Technical Bulletin

Topic: Performance of modified LCD panels versus standard LCD panels.

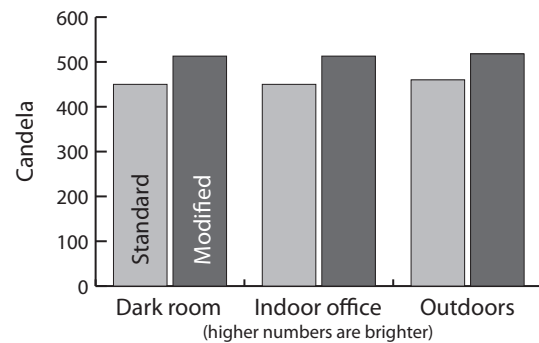
Background: FSN Medical Technologies constantly looks for ways to upgrade its products. We have developed a process, seeking to improve picture quality, and applied it to our LCD displays.

Result: These modified LCD panels show an improvement in contrast ratio and brightness, plus improved humidity resistance and break-age resistance.

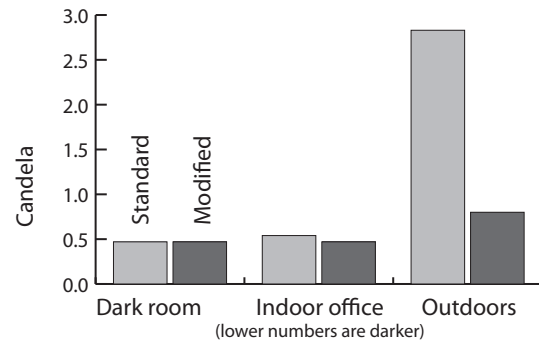
Comparison item: Contrast ratio

Standard LCD (cd/m ²)	Modified LCD (cd/m ²)
Dark room	957.4:1	1091.5:1
Indoor office	833.3:1	1091.5:1
Outdoors	162.54:1	647.50:1
